Planning Advisory Committee December 6th, 2021

Subject: Rezoning - 36 Unit Apartment Building - 95 Hampton Road

Subject: Traffic Memo – Hampton Road Apartments Traffic Impact Statement

Re: 97 Hampton Road - Water Demands - KV Properties

SITE PLAN

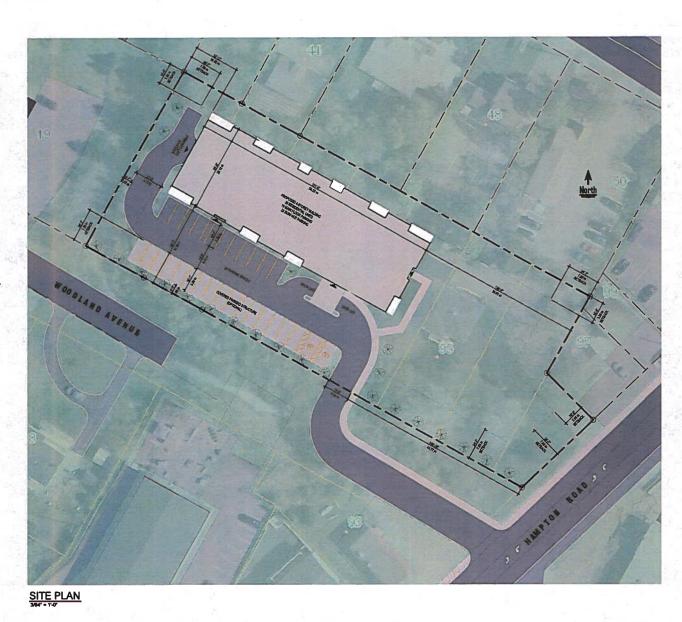
The proposed building also is setback 5meters from the shared rear property boundary with 42-48 Clark Road. The proposed 5-meter setback does not meet the by-law minimum requirement of a 7.5-meter setback. Staff are reviewing the site plan and building location with the applicant to evaluate alternatives.

1.	Type of use;	The multi-unit residential is a compatible use with the surrounding businesses.
2.	Height, bulk and lot coverage of any proposed building;	Staff's main concern is the proposed reduced rear yard setback of 5m, otherwise the proposed building Height, bulk and lot coverage comply with the by-law.
